PUBLIC INTEREST REVIEW FOR GROUNDWATER APPLICATIONS

SUBJECT: Application G- 17940 Supersedes review of _____
Date of Review(s)

A. GENERAL INFORMATION: Applicant's Name: Gerrit & Patricia Jager & John & Karen Simmons
 County: Harney

Greater Harney Valley Groundwater Level Trends

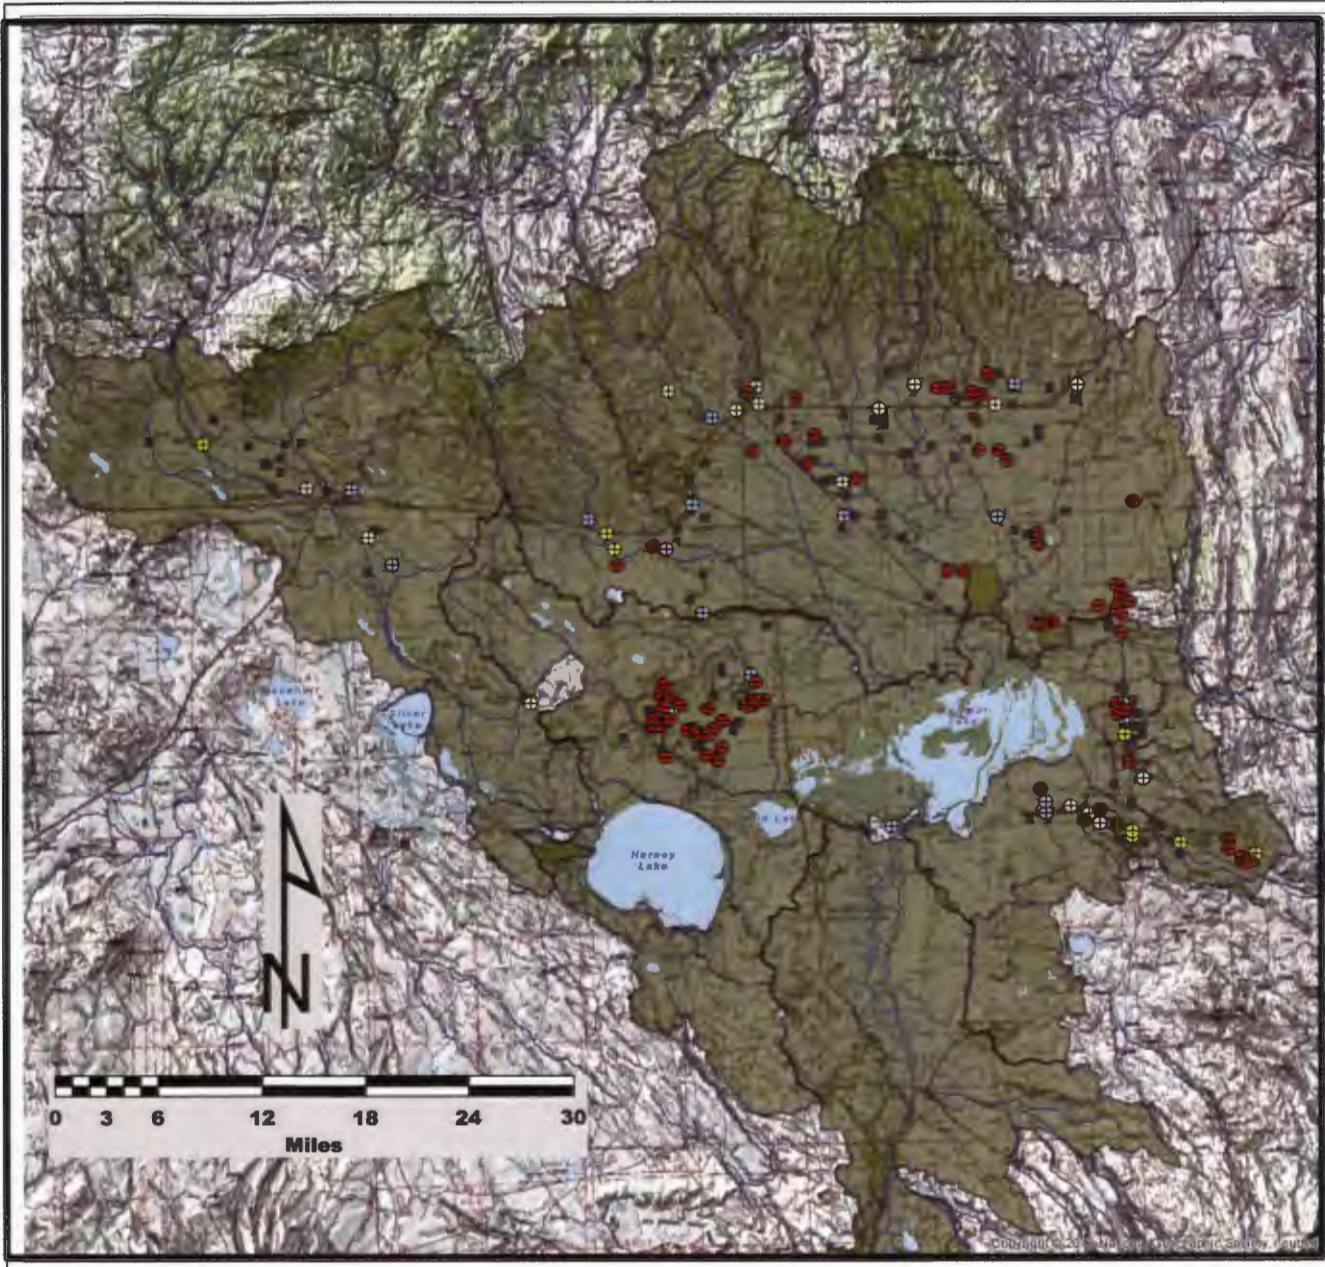
Groundwater is determined to be over-appropriated and the proposed use is not within the capacity of the resource. The proposed well(s) is within, near, or surrounded by an area of observed groundwater level decline (see attached map). The decline is evidence that demand for groundwater is exceeding the average annual recharge. A preliminary analysis by the Department indicates the volume of groundwater permitted for annual use exceeds the average annual volume of recharge to groundwater. The Department estimates 30 to 40 percent of the total permitted acreage have yet to be developed. Their development will likely worsen the groundwater level decline.

If a permit is issued, the following conditions are recommended:

7B: Interference Condition

7F: Proposed Well location Condition

7N: Annual Measurement and Decline Condition

7P: Well Tag Condition

7T: Dedicated Measuring Tube Condition for all POA wells

Flow meter condition: Use the water rights "large" permit condition requiring a totalizing flow meter at each well and reporting
